Representation for Current Development Application - submission confirmation

Thank you for your representation regarding development application number: DA201731192

- **Construction of site servicing along Mortimer Lewis Drive including stormwater, water, sewer and shared trench. Upgrade of the existing kerb on Mortimer Lewis Drive and bulk earthworks. Removal of regulated trees as shown on the Tree Management plans and proposed sewer pump station to service Blocks 4 and 5 and sewer rising main to connect across Drakeford Drive; and associated works;**

Client	LAND DEVELOPMENT AGENCY
Project	GREENWAY SECTION 28 - BLOCKS 3, 4 & 5
Title	PAVEMENT PLAN SHEET 1 OF 2

Status	PRELIMINARY			
	NOT TO BE USED FOR CONSTRUCTION PURPOSES			
Datum	AHD	Scale	1:500	
Size			A1	
Drawing Number	50517027-C-1016		Revision	A

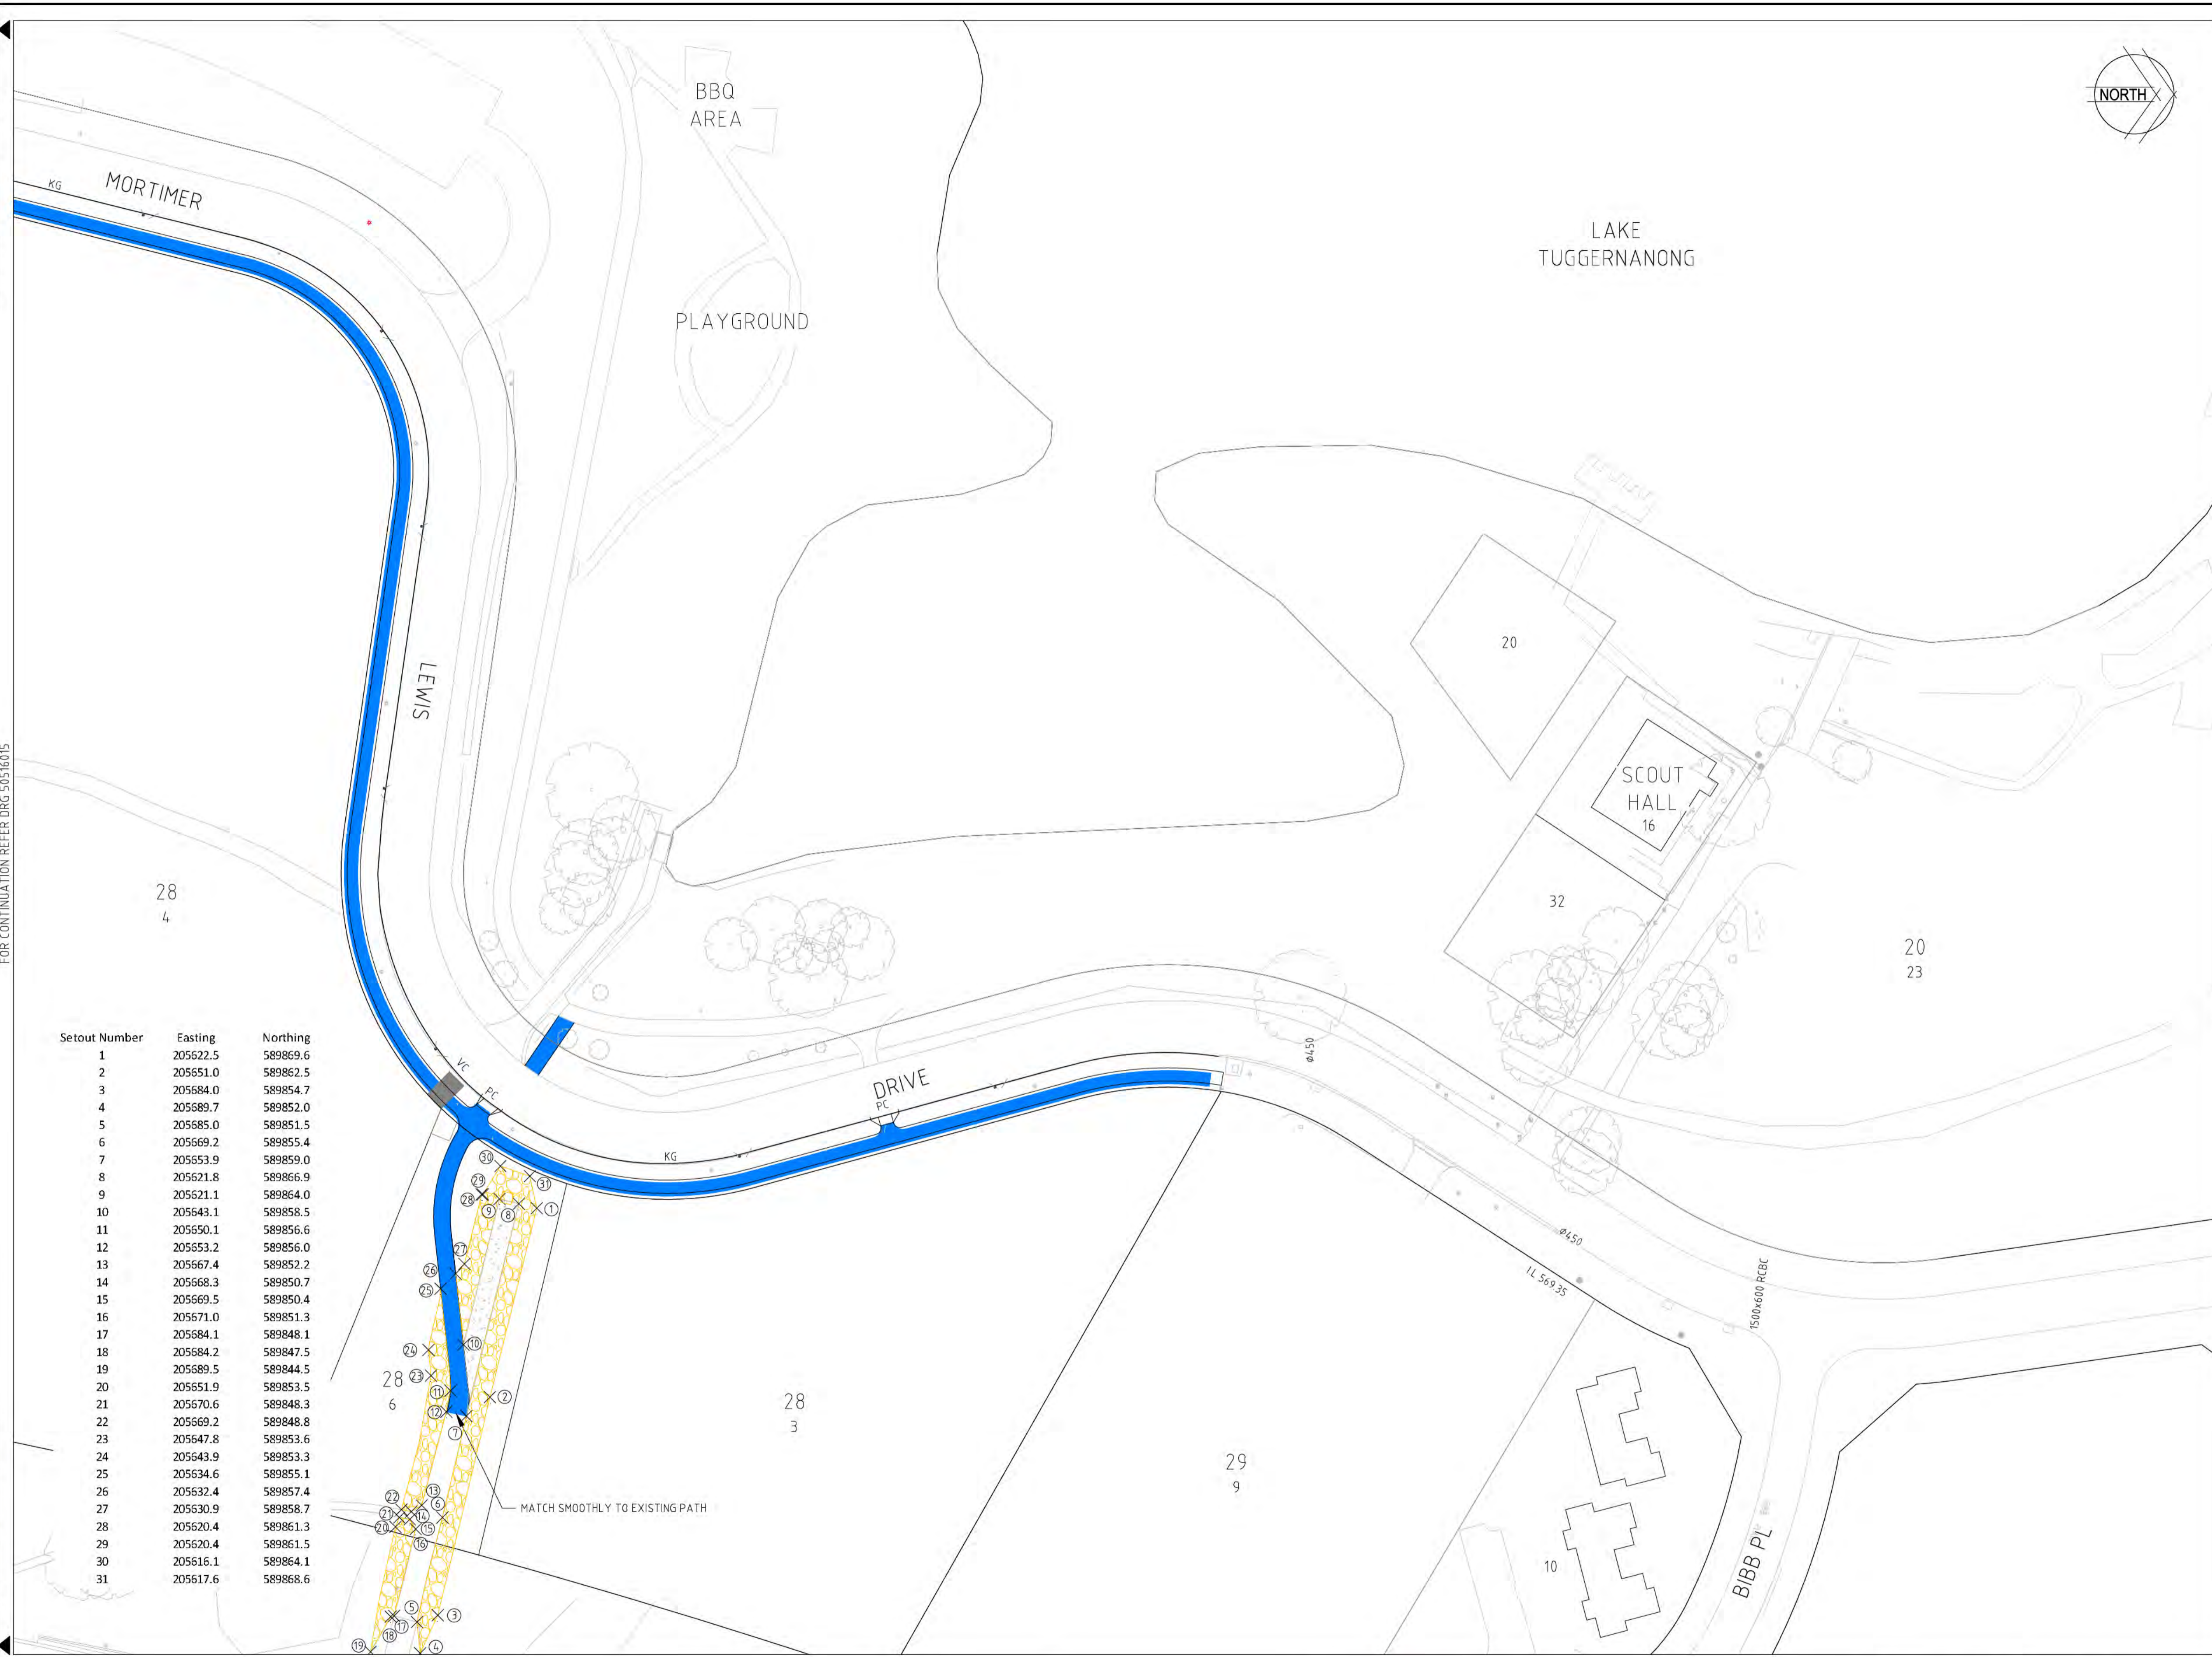
7. Urban Treescapes can support the sewer pump station as shown on the Sewer Pump Station Access plan (50157027-C-1026 Rev A) however please indicate which small trees will require removal. Please also confirm the log barriers that will be removed adjacent to sewer pump will be replaced once the sewer pump access bay has been constructed to prevent vehicles gaining access into the urban open space around Lake Tuggeranong (Place Management may wish to provide further advice).
